SERVICE BULLETIN

KAIR11001 – Front Chassis Tanarg

LANAS 28 March 2011

SUBJECT : Cracks in front chassis (ref : E305910) Tanarg.

Zone à
inspecter

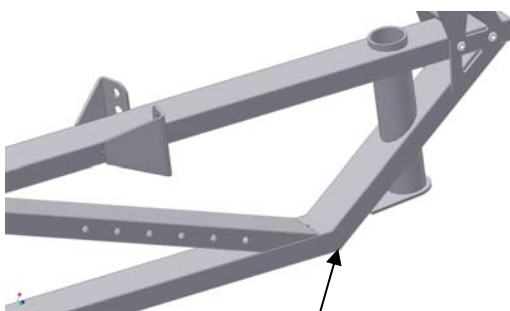
In a unique case, on a Tanarg trike, a crack on the 40x20 tube behind the lower level of the axis of the fork, at the point of soldering.

Zone à inspecter : entre le palonnier et le palier inférieur de la fourche.

- As a precaution, we ask that before next flight, this zone should be carefully inspected.
- The checking of this particular point should be included in pre-flight checks;
- In case of cracking, stop flights and contact the factory for replacement of the front chassis.
